Case No. 21-2939-NMP

Petition of Randolph Davis Road Solar LLC for a  
Certificate of public good, pursuant to 30  
V.S.A. §§ 248 and 8010, authorizing the  
Installation and operation of a 500kW group  
Net-metered solar electric generation system in  
Randolph, Vermont

**NEIGHBOR INTERVENORS' SECOND MOTION TO DISMISS PETITION,**  
**or in the alternative,**  
**MOTION FOR STAY OF PROCEEDING and**  
**MOTION TO PERMIT ENTRY & INSPECTION OF THE PREMISES FOR A**  
**WETLANDS DELINEATION and**  
**REVISION OF THE SCHEDULING ORDER**

Figure 1

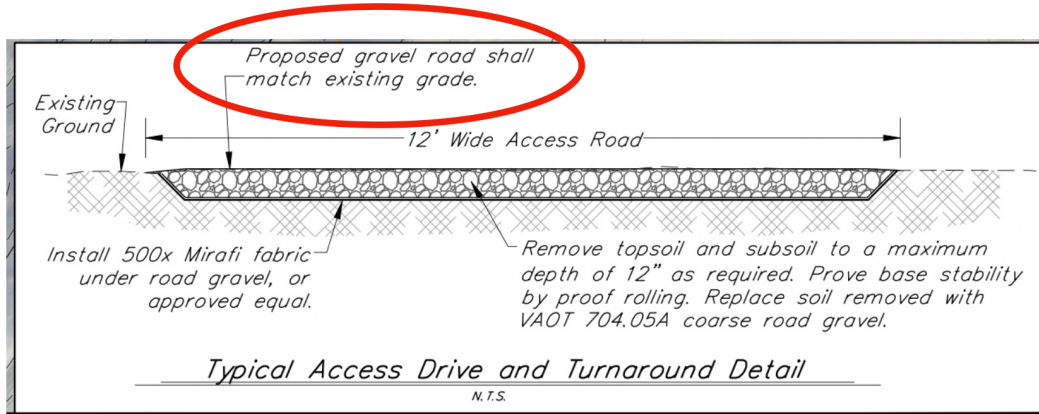
Petitioner's site plan fails to comply with the requirements of the Rules because as we saw on the site visit, there are streams and wetlands on site, and a vernal pool complex contiguous with the site that were omitted from the submission of the Petitioner. Also, the Petitioner's site plan contains a cross section of the access road that is not typical of most of the proposed access road. We saw on the site visit that the access road bed is not level, but the submitted cross section of the road (RDS MS-2A) is on a **level existing grade**. (see Figure 1, below)

According to the site plan, Petitioner proposes to develop the access road by digging a trench 12 feet wide and up to 1 foot deep, stockpiling the Prime Agricultural Soils (PAS) from the trench, and filling the trench with gravel. At decommissioning, the gravel is to be scooped out of the trench and the PAS is to be restored to the road bed from the stockpile. Neighbor Intervenors would admit that the Petitioner's plan to restore the PAS is feasible, but only if the cross sections of the access road were actually as the Petitioner depicted in their misleading submission.

Figure 2

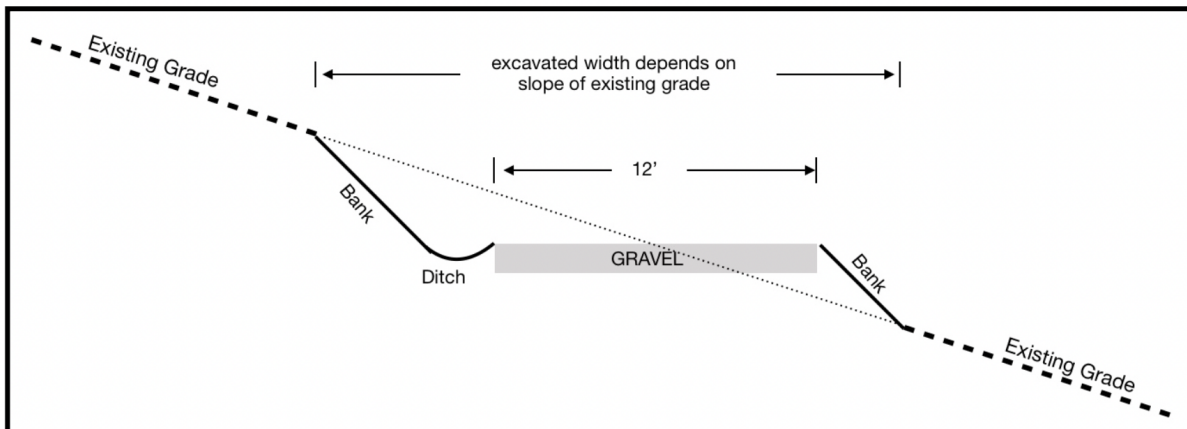
Neighbor Intervenors' Figure 2 (below) shows some typical elements of a cross section of a road that is cut into an existing sloped grade.

The excavated width of such a road is much wider than the 12 ft roadbed (Figure 2),

and both PAS topsoils and subsoils will be disturbed and co-mingled by the excavation. On some sections of the proposed road, the swath of excavated soils is 40 feet wide (as shown on RDS MS-2A). During the 25 year life of the project, road gravel may migrate into the ditch and may migrate down the lower embankment. The Parties cannot evaluate the Petitioner's plan for removal of gravel and restoration of PAS with the inapplicable and misleading cross section of the road that has been submitted.
